WNP-2
SAFETY RELATED MECHANICAL
EQUIPMENT LIST

SEISMIC QUALIFICATION INFORMATION

February 12, 1982

Washington Public Power Supply System

FIG. 8040.088-1

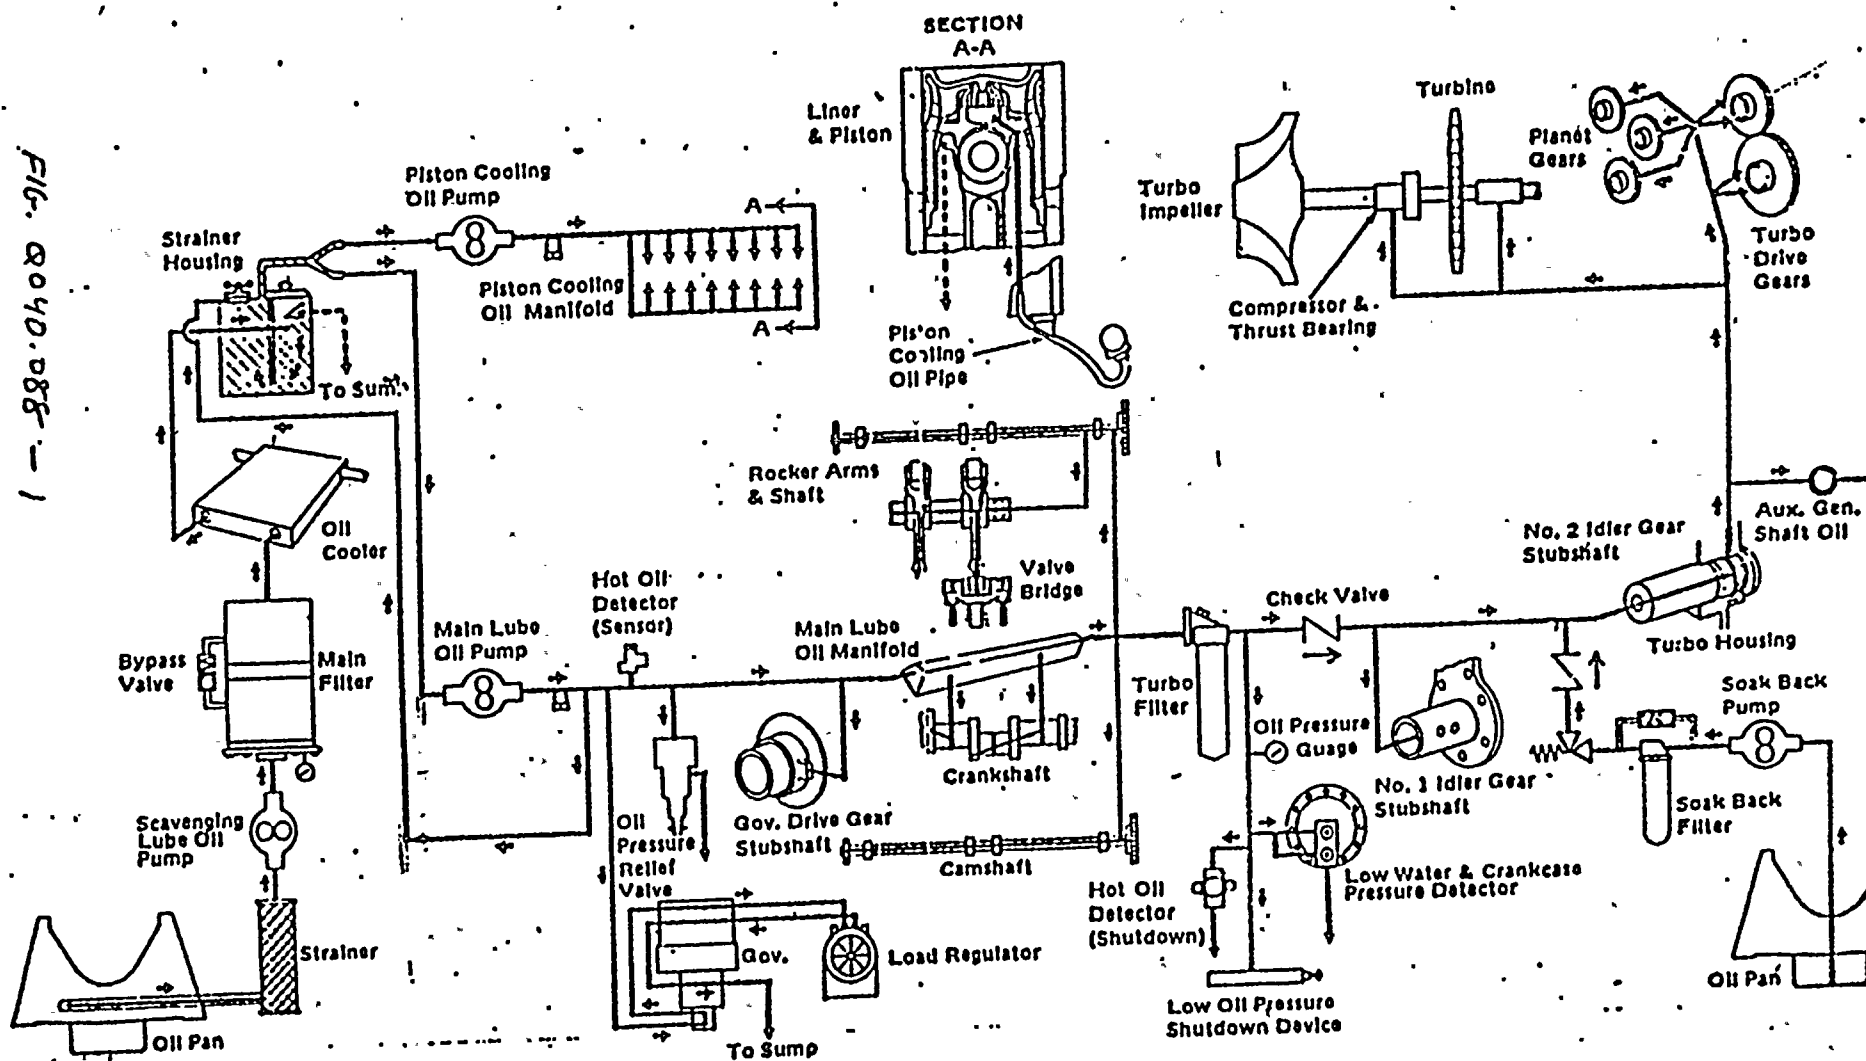
Figure 9.5-4 shows an immersion heater in the diesel engine cooling water system. The heater is connected to the engine driven pumps' suction lines and to the inlet to the lube oil cooler. The FSAR in section 9.5.5 does not provide a detailed description of how the diesel engine cooling water system operates during standby conditions nor does the design of this system seem to provide for preheating of the jacket water to enhance engine start capability. Provide a detailed description of how the diesel engine cooling water system operates on standby conditions.

The modified system is provided with sight glasses located on the line between the main bearing pressure pump discharge elbow and camshaft counter weight housing. The lower sight glass indicates the engine oil gallery is full while the upper sight glass indicates that oil level is above the camshaft. See Figures 040.088-1 and 040.088-2.

PENETRATIONS X-103 A-D — PRIMARY &
BACKUP SHORT CIRCUIT PROTECTION

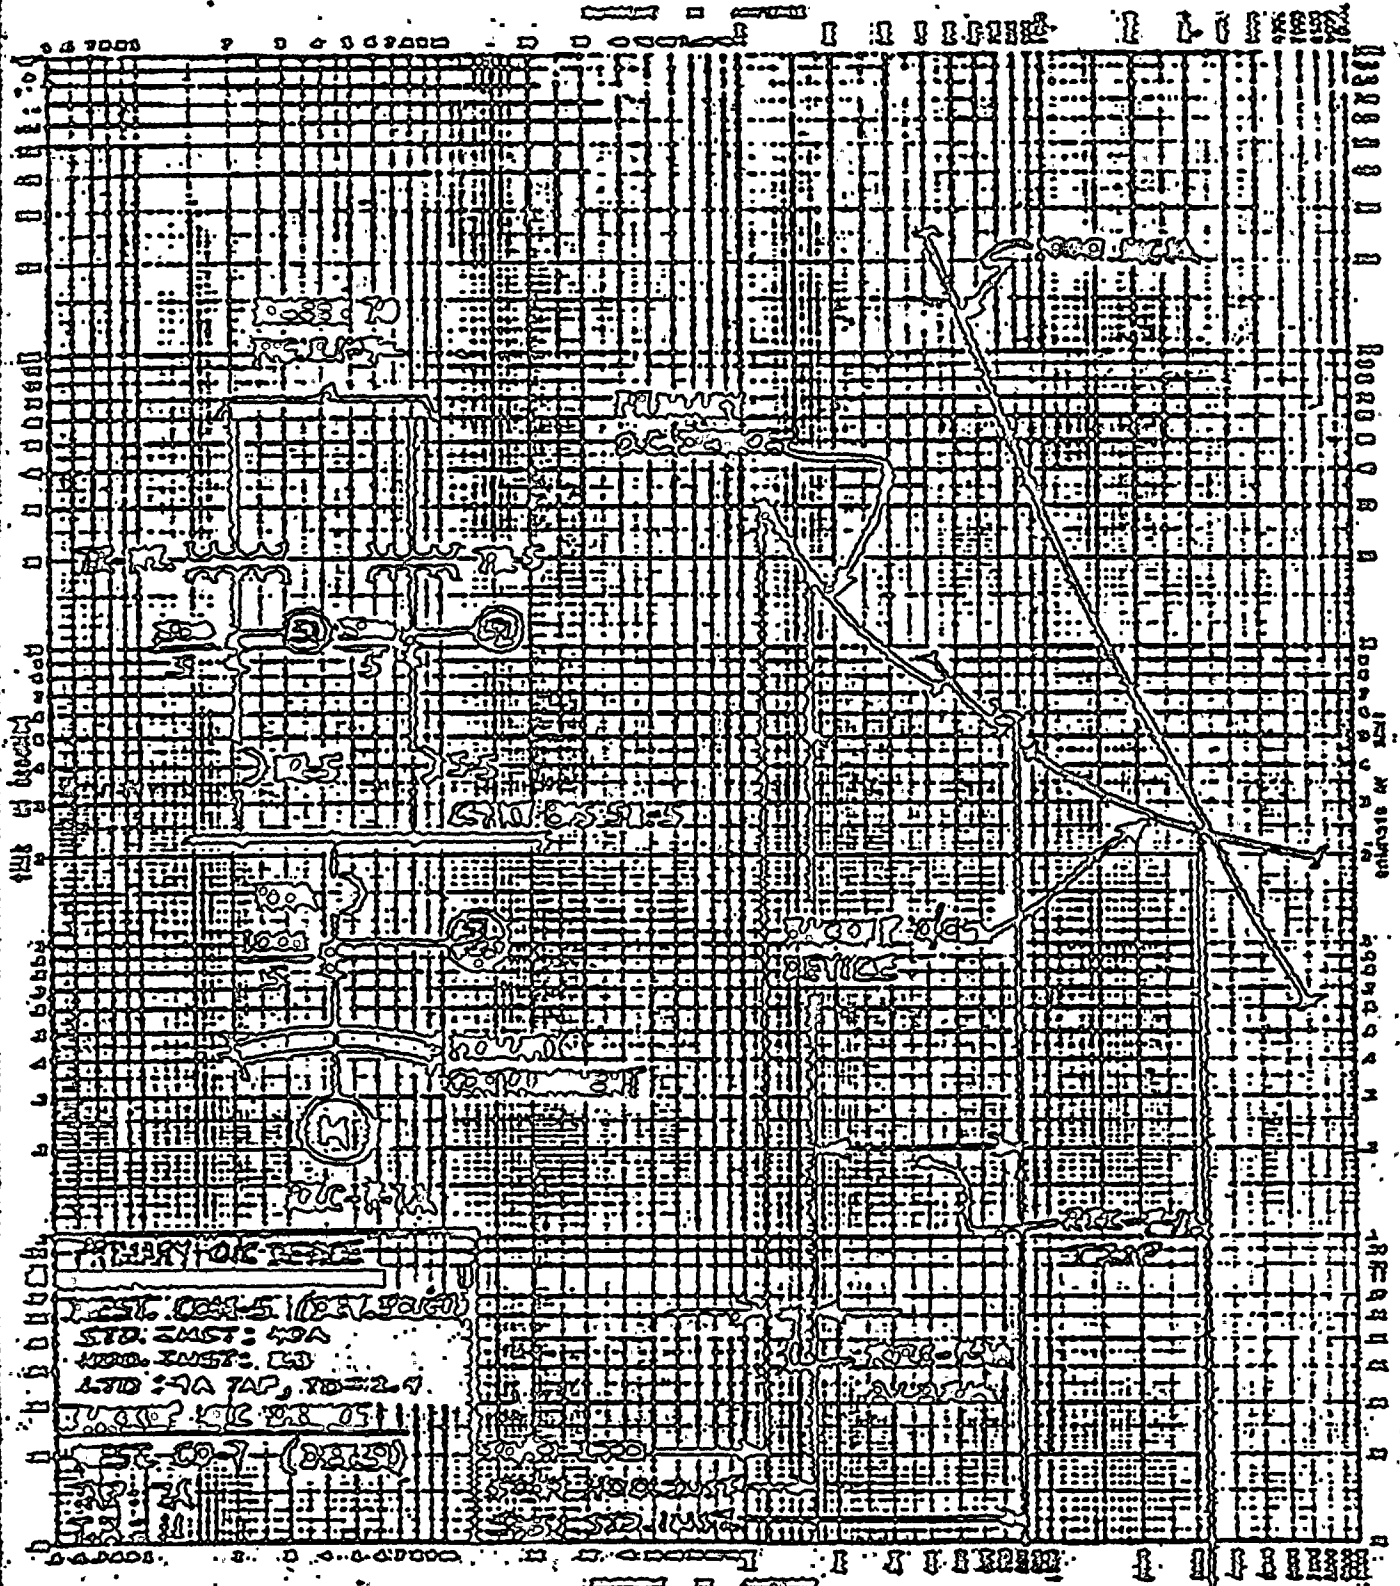
Figure 040.034-3 (X-103 series penetrations) and Tables 040.034-2 through 040.034-4 (X-104, 105, 107 series penetrations) indicate the setpoints of the primary and backup protective devices. As indicated in Item (b) above, setpoint values have a limited usefulness. Analysis is designed to verify that conductor I^2T capability is not exceeded at any point along its thermal limit curve for all possible short circuit current levels (and the unique protective device clearing times for each short circuit current level). Consideration of the primary and backup protective device clearing times at all points along the clearing time curves (not just at the setpoint values) is required.

The analysis presented in Tables 040.034-2 through 040.034-4, and Figures 040.034-1 through 040.034-10 verify for each individual containment penetration conductor that penetration seal integrity failure due to excessive short circuit induced heating does not occur, even for the case where the primary protective device fails to operate and the backup protective device is called upon to clear the fault. The I^2T of the maximum expected fault is, in every case, less than the I^2T rating of the penetration conductor.
